**Subject:** Public Comment - Flight Procedures and Part 150 may have used incorrect baseline contour data

Committee members:

Figure 1

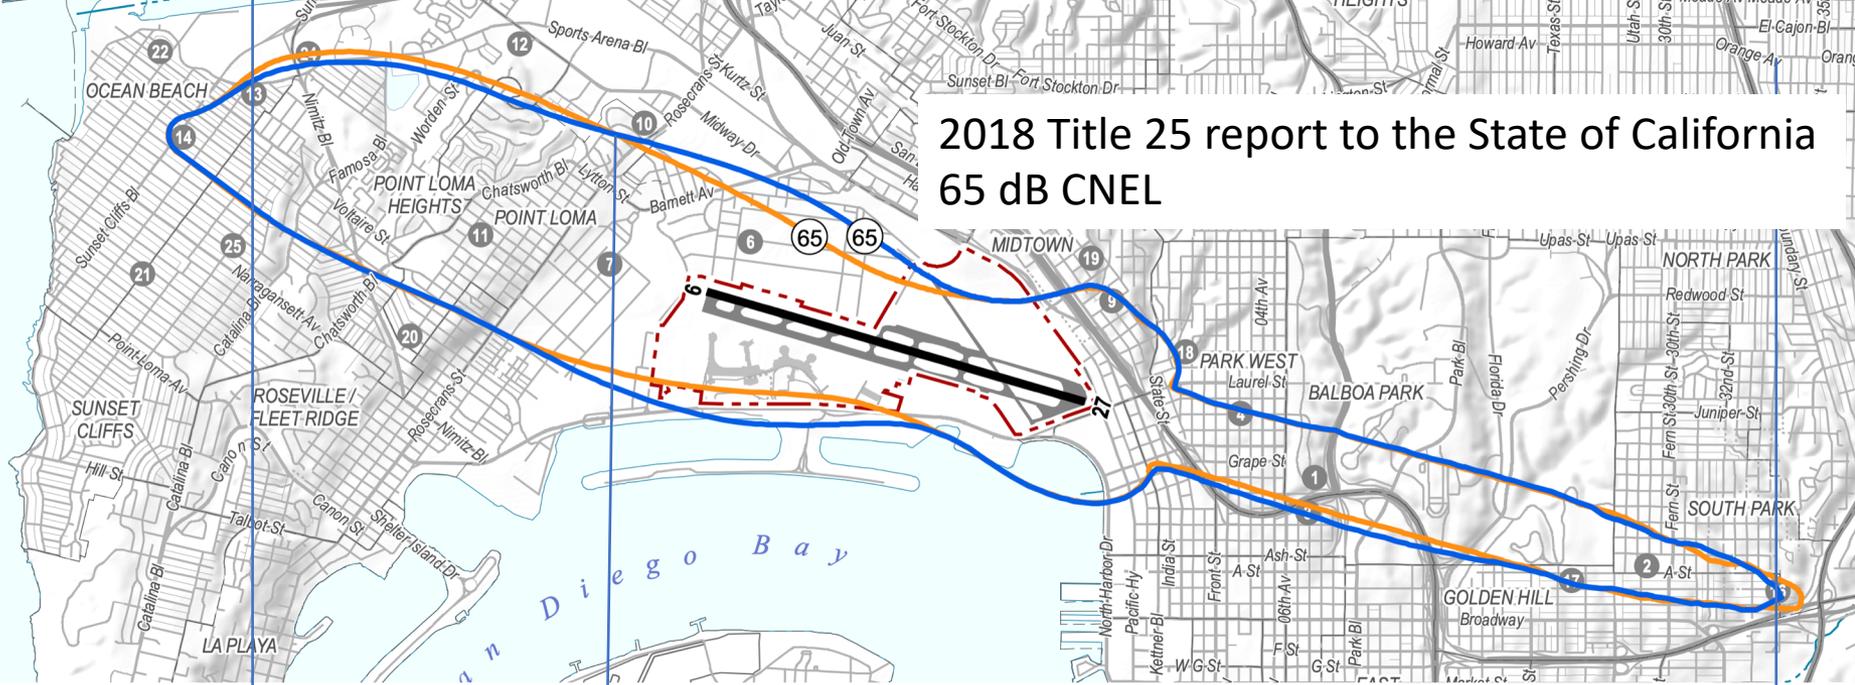
I was also working with the Title 21 data that is reported to the State quarterly. I was correlating noise monitor data and found an inconsistency with the total contour size for the FPA and Part 150 Study contour. I used the same tool and found the total contour area for the Title 21 data is about 5 square miles. This is a big difference with major implications to "incompatible noise area" population and number of housing units.

But perhaps the most telling evidence is the position of the noise monitors relative to the contour peak on the departure side. Note that the noise monitors (e.g., #24) is well outside of the peak for the contour used in the FPA and Part 150 Study, but on or slightly inside the contour for the Title 21 contour. Further examination of the contours revealed that the areas on the arrival side are virtually the same. This means that the area on the departure side for the SDIA Title 21 contour is one square mile larger than for the contour used in the FPA and Part 150 studies.

Figure 3

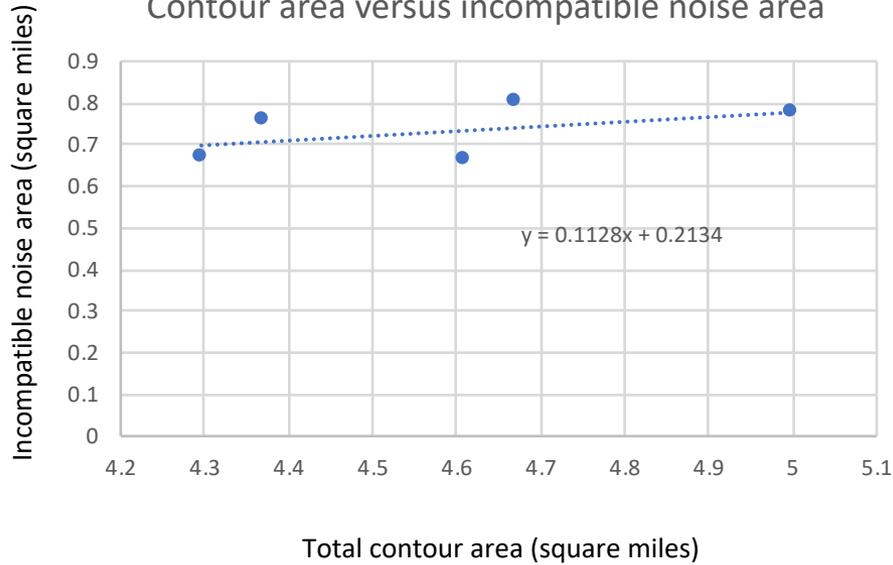
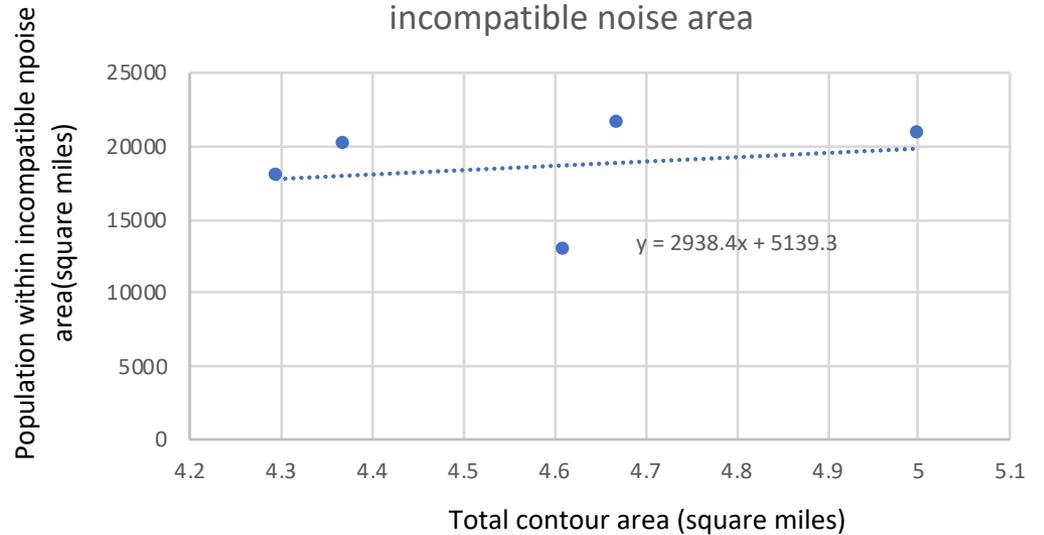
My last point addresses a potential issue that might be raised by the Airport Authority Noise Abatement office personnel; the FPA and Part 150 only deal with the incompatible noise area and not the total contour area. The third graph does show a positive correlation between the total contour area and the

incompatible noise area, which is of course the criterion used by the FAA. The bottom line is that it appears that the wrong baseline contour was used for the 2018 baseline. And if this is the case, then there would be substantial ramifications for the 2026 projected areas, population and housing units within the 65 dB CNEL.

Figure 2

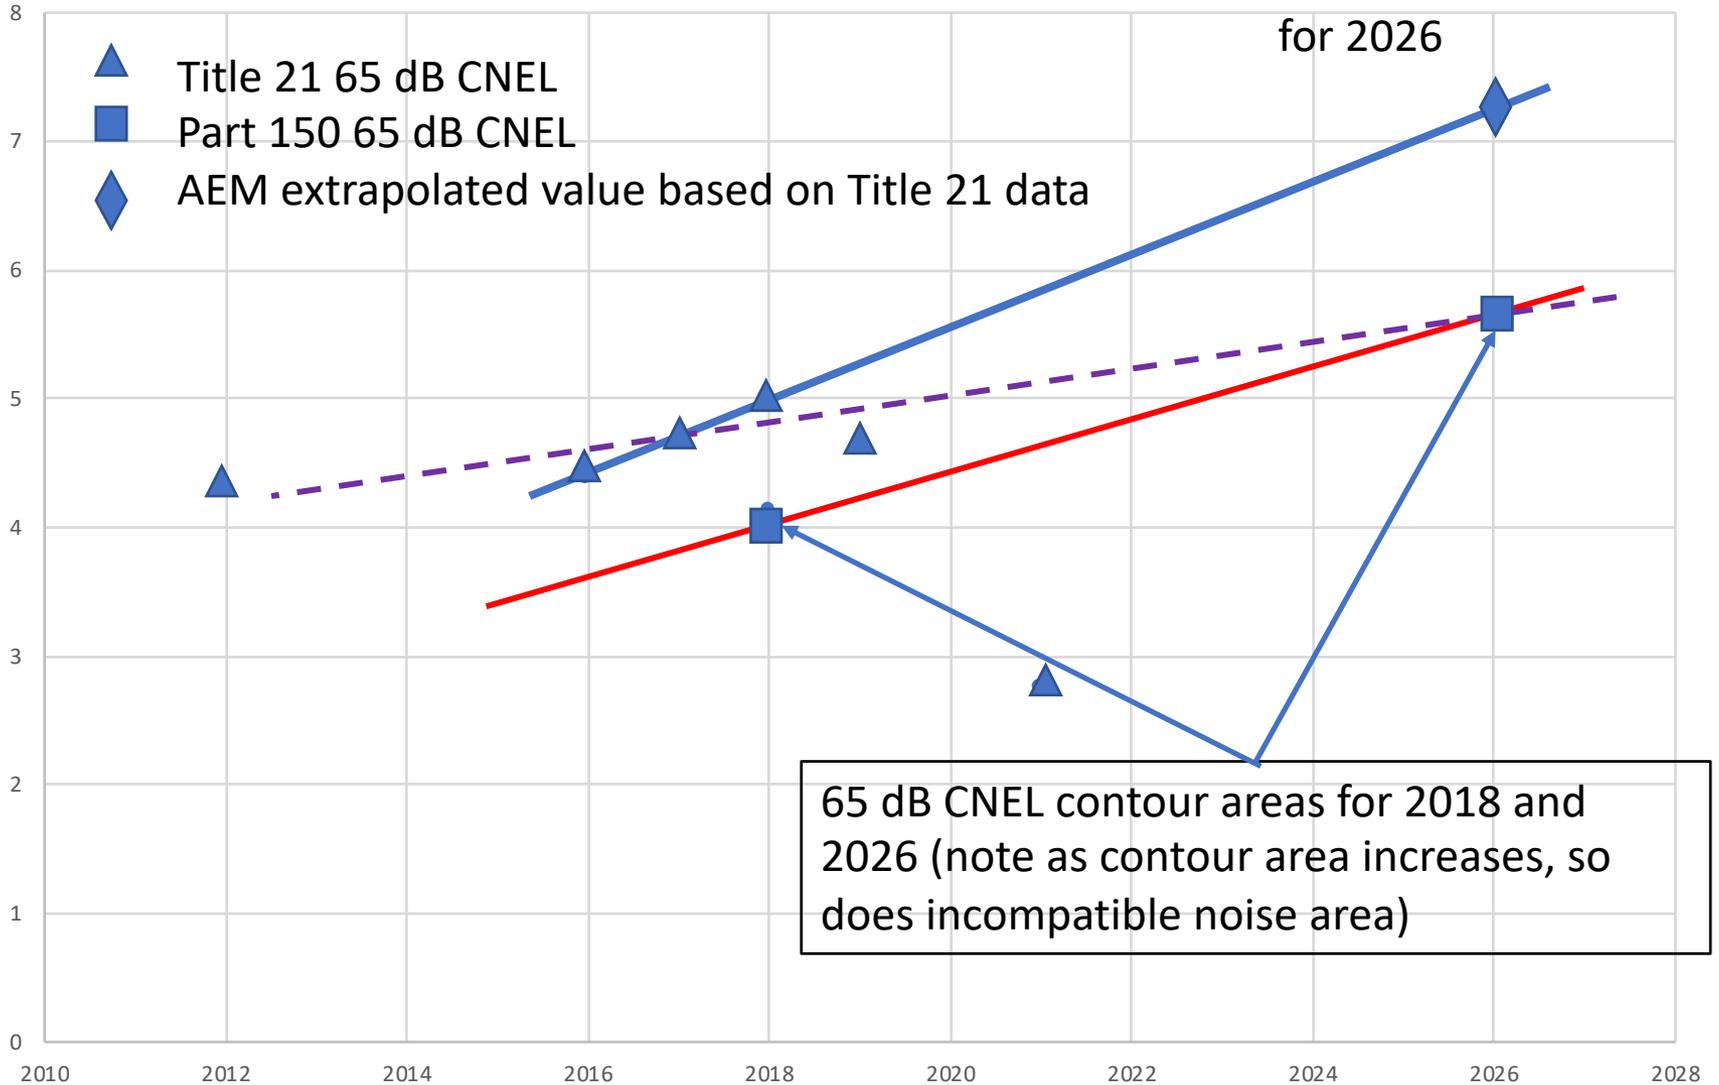
The question arose whether the data to the State is consistent with data from other years. I then used the archive data at SDIA Noise 101 to determine the total contour area for a number of years to confirm the 2018 data. These are the triangle points in Figure 2. While 2018 is the largest contour, none of the contours come close to the 4.0 square mile contour used in the FPA and Part 150 Study. I also calculated the total contour area for the 2026 projection and found it to be about 5.6 square miles (also shown in Figure 2). The big question though is whether the 2026 projected total contour area suffers from the same short coming as the 2018 contour, or somehow it has been corrected. Based on everything we saw and heard during the two studies, it is much easier to believe that the 2026 at 5.6 square miles is based on the 4.0 square mile contour data.

If this is the case, and the real area is 5 square miles, then it is possible that the 2026 total contour is more like 7.2 square miles, as shown on the graph in Figure 2. Clearly, a 7.2 square mile contour would engulf all of the northern residential areas in Ocean Beach and potentially could make it to Mission Beach.

The Airport Authority submitted the draft part 150 for consideration by the FAA, but the implications of use of wrong data is too substantial to wait five to ten years to rectify. It is proposed that a study be performed to confirm one way or the other by an independent third party if the 2018 baseline contour is or is not correct.
